Preliminary Site Development Plans
for
Valley West Shopping Center
Bloomington, Minnesota

Revision History
No. Date By Submittal / Revision
09/30/20 JGP CUP/PERMIT SET

CASE #PL2020-190

Sheet Title
**VEHICLE TURN
EXHIBIT**

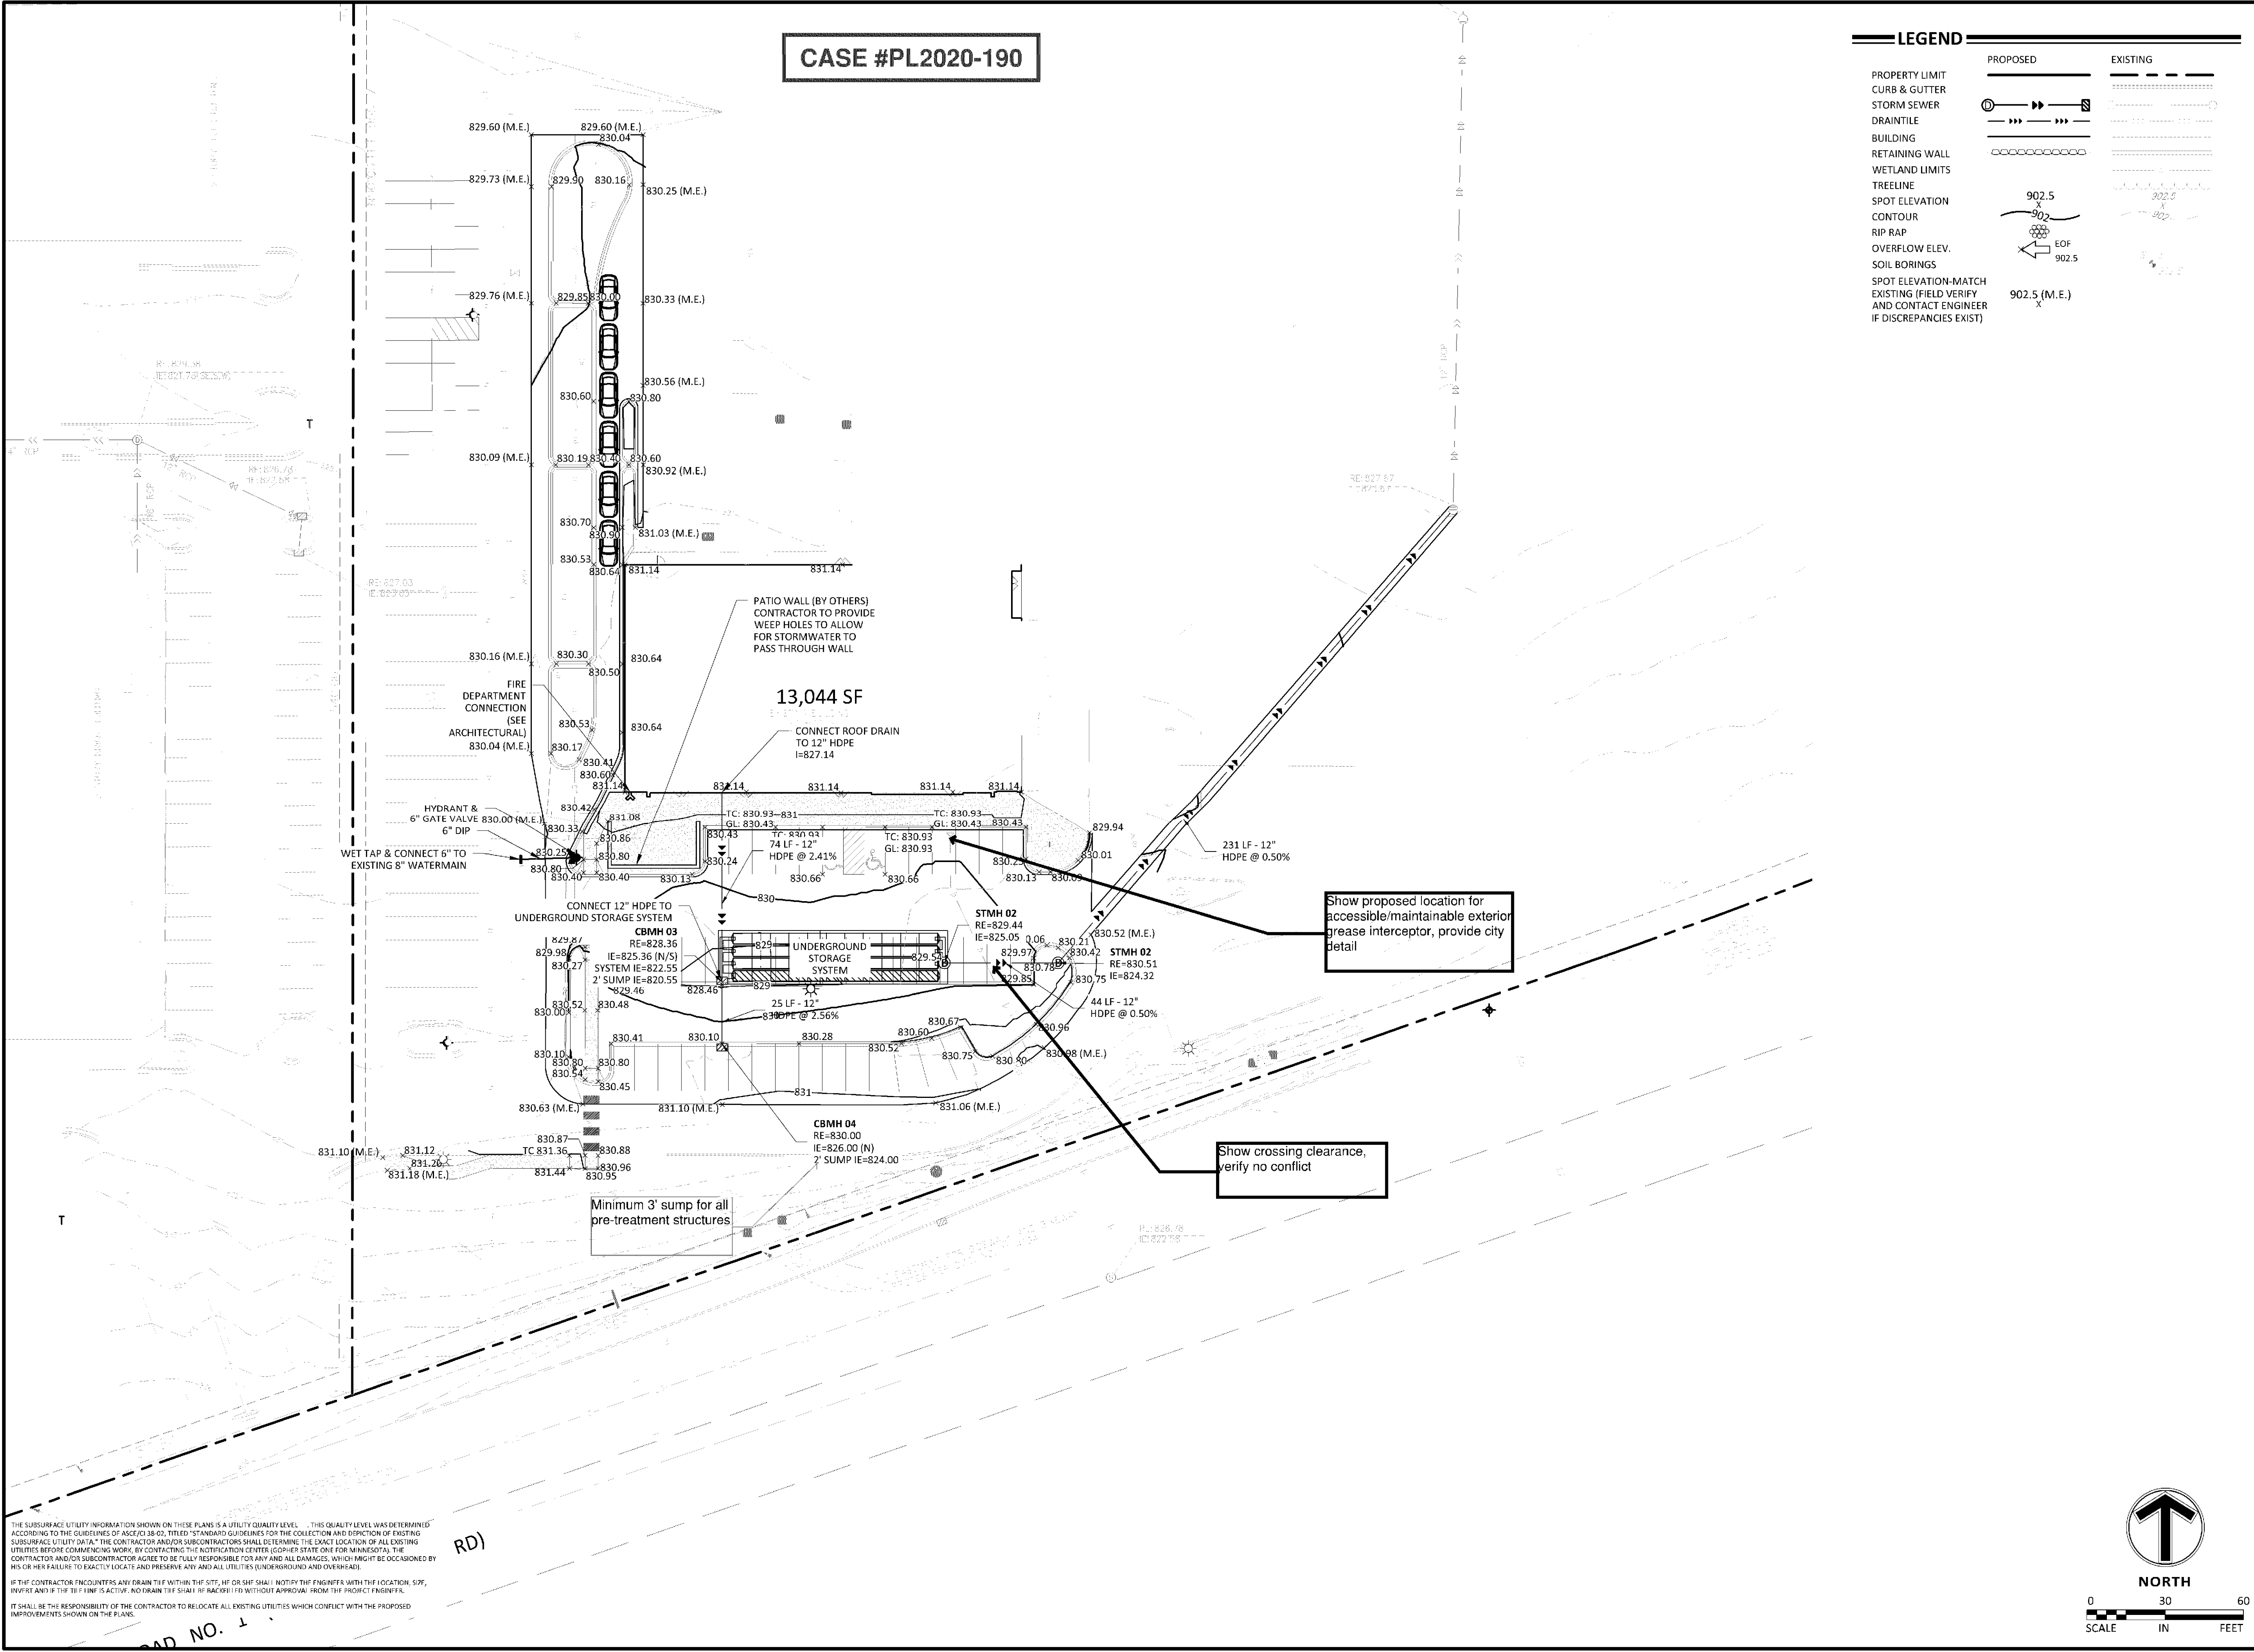
Several hydrants exist in islands/parking area along the west side near the FDC's. Access to the hydrants shall be maintained.

Access to existing FDC locations along the west side shall be maintained. It appears that this configuration may block two or more.
